STATE OF NORTH CAROLINA
DEPARTMENT OF TRANSPORTATION

March 30, 2015

Subject: **Request for Modification to Individual Section 404 and Section 401 Water Quality Certification** for the proposed NC 133 Connector from NC 211-133 (Southport Supply Road) to NC 87-133 (River Road), Brunswick County. Federal Aid Project No. STP-133(3), Debit \$570.00 from WBS No. 34531.1.1, TIP R-3324

PERMIT DRAWING
SHEET 50 OF 54
 Revised: 3/30/15

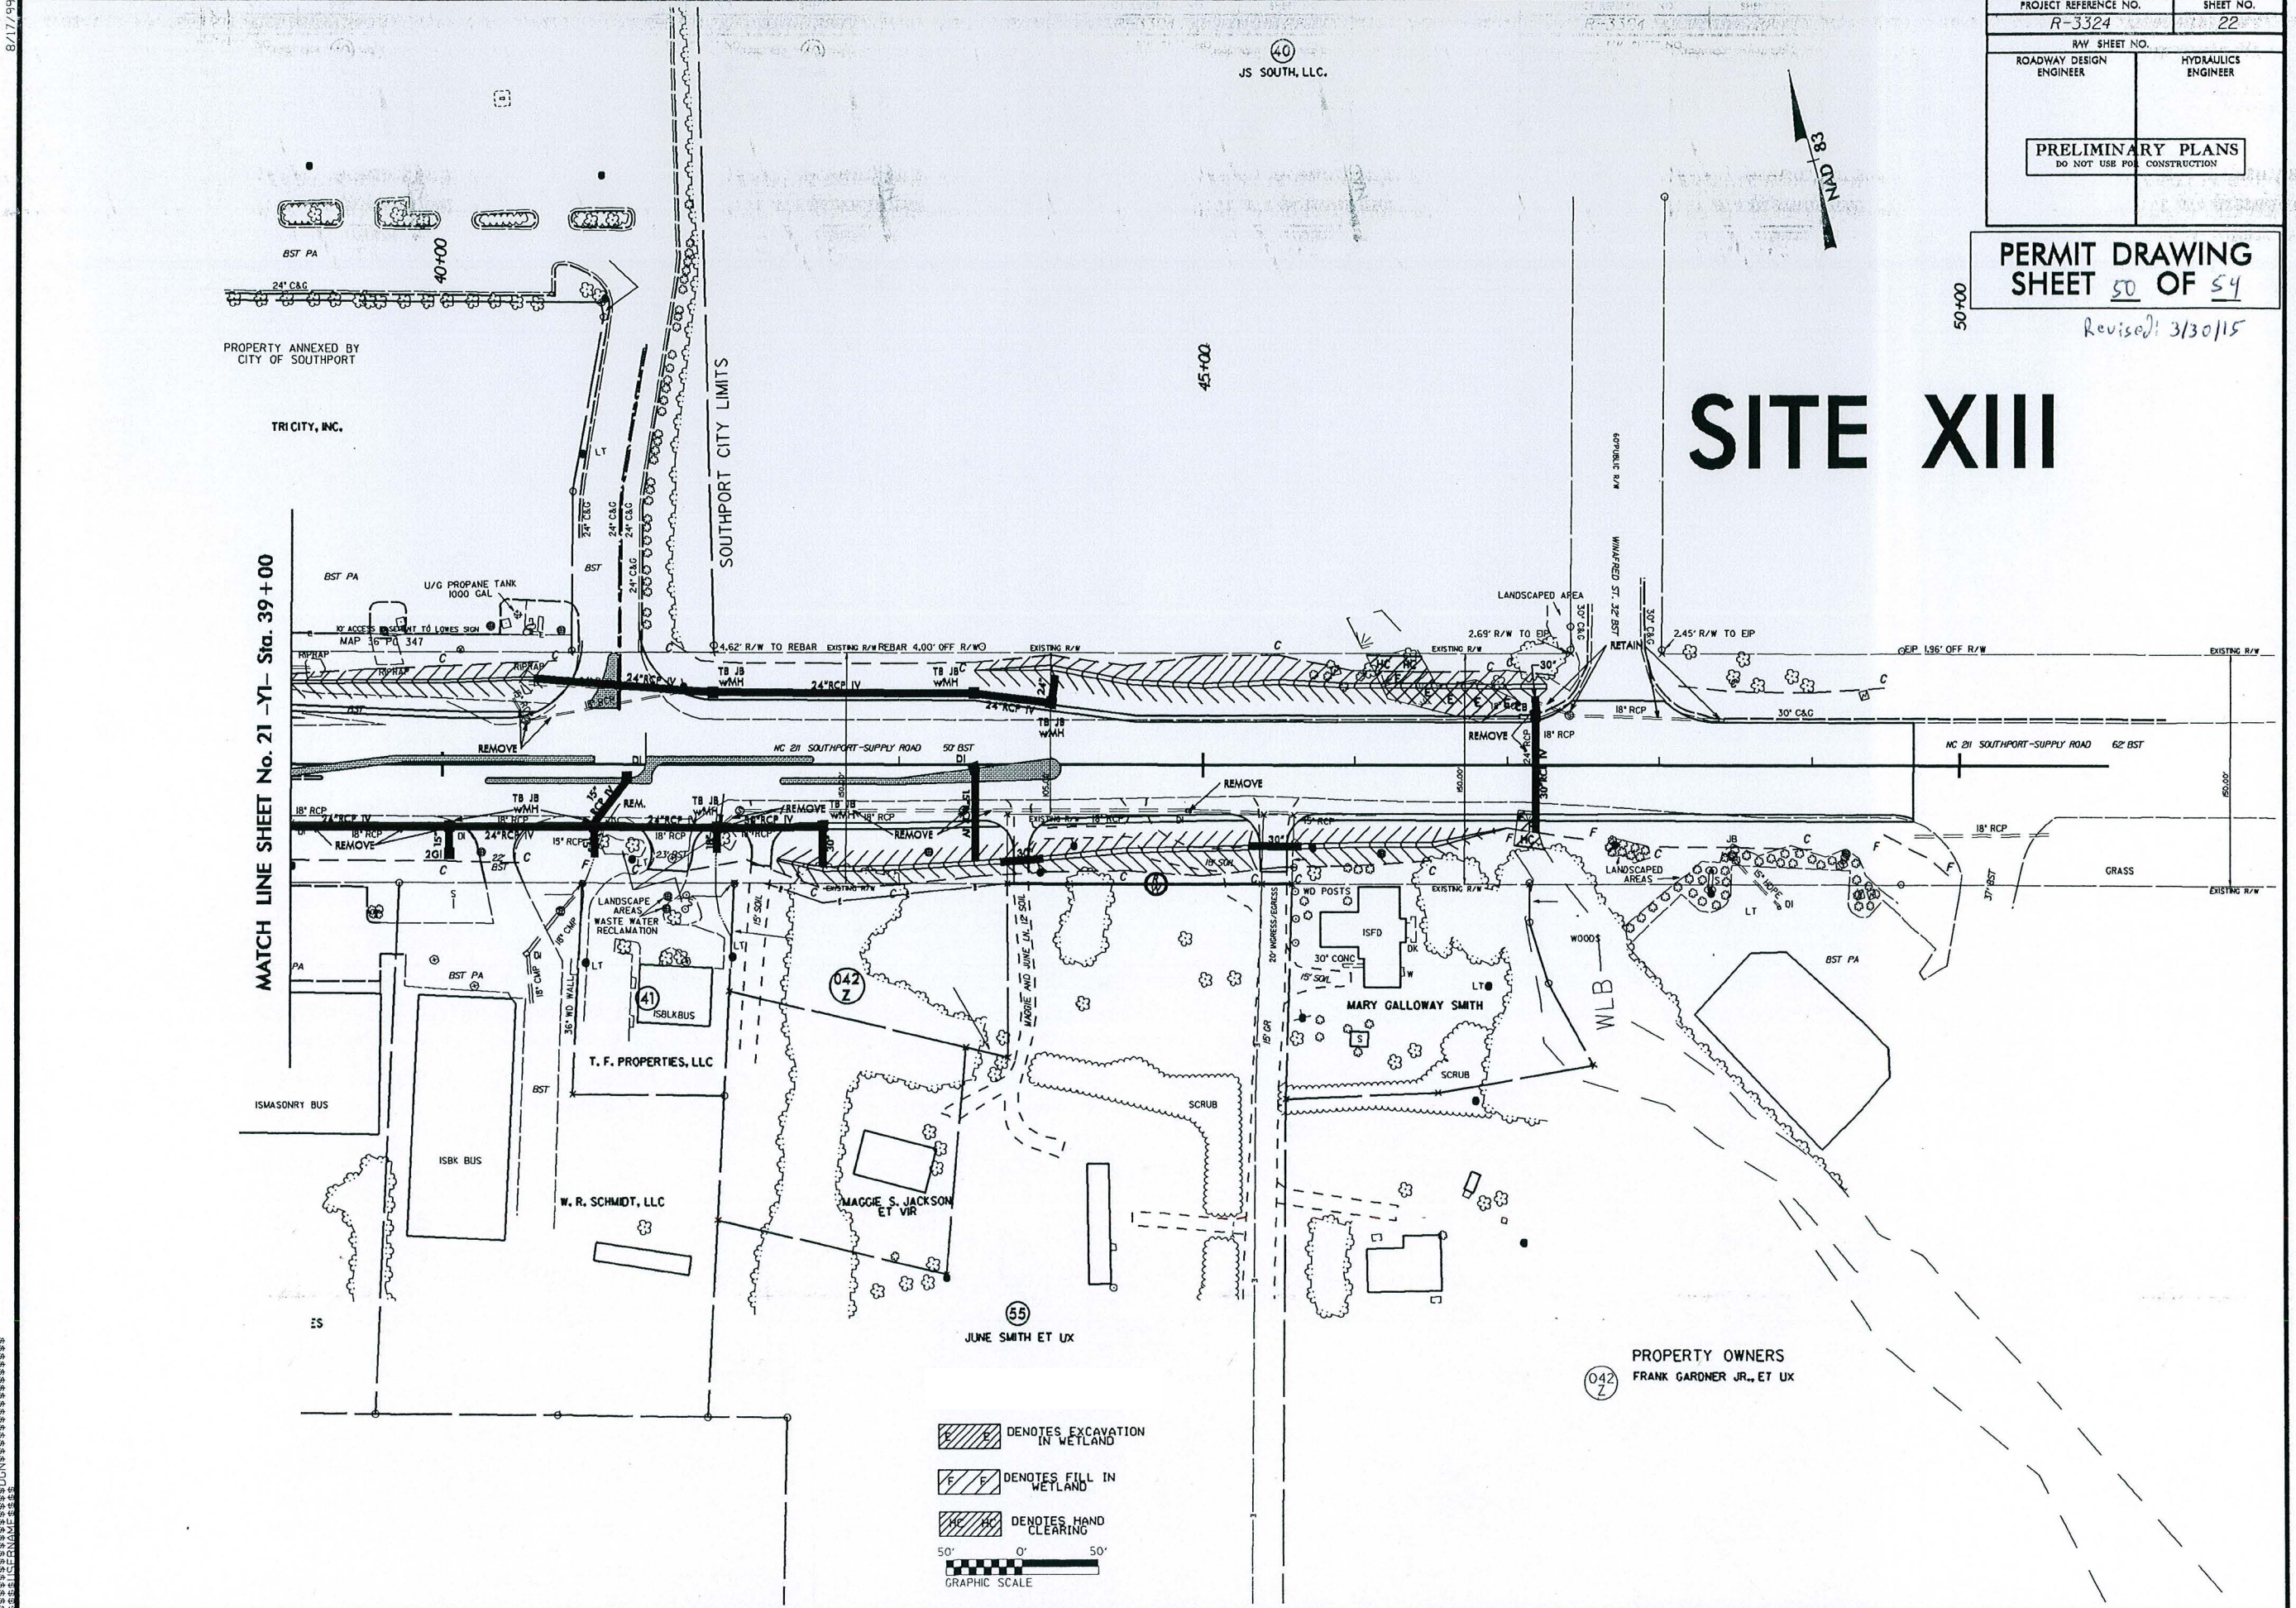
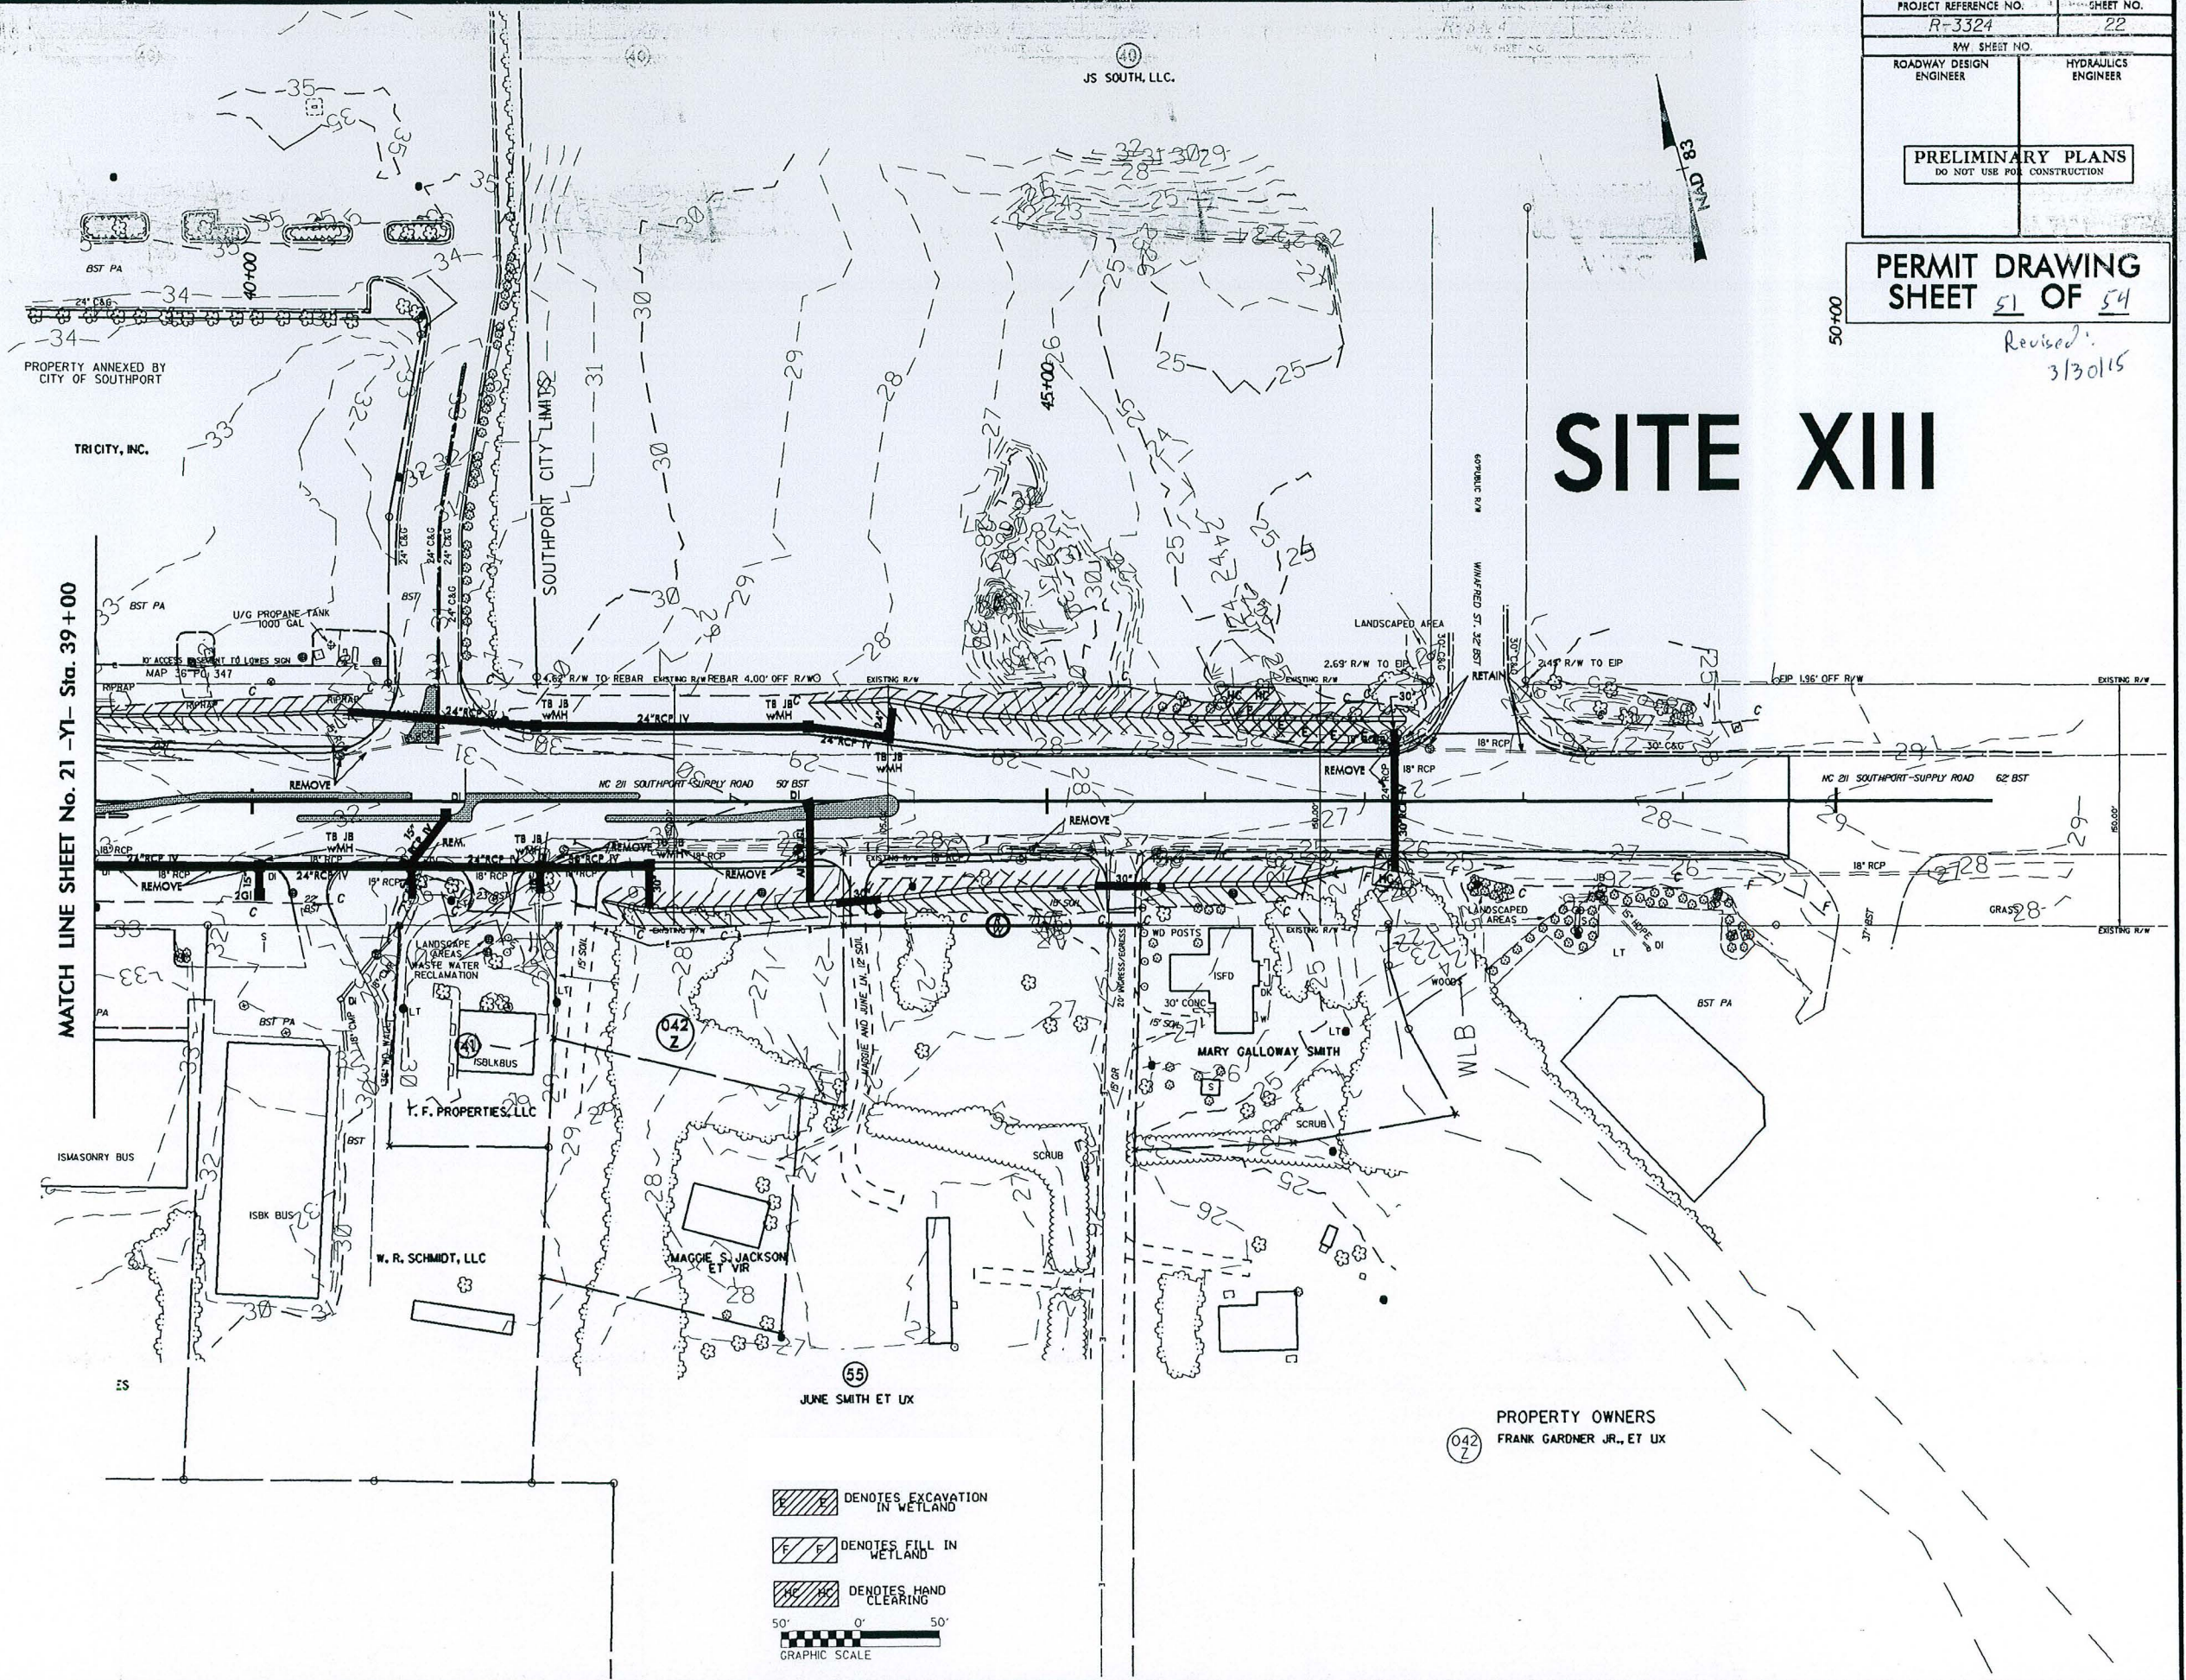
impacted and mitigation already being provided. Site #13 mechanized clearing impacts were changed back to hand clearing as that was all that was necessary.
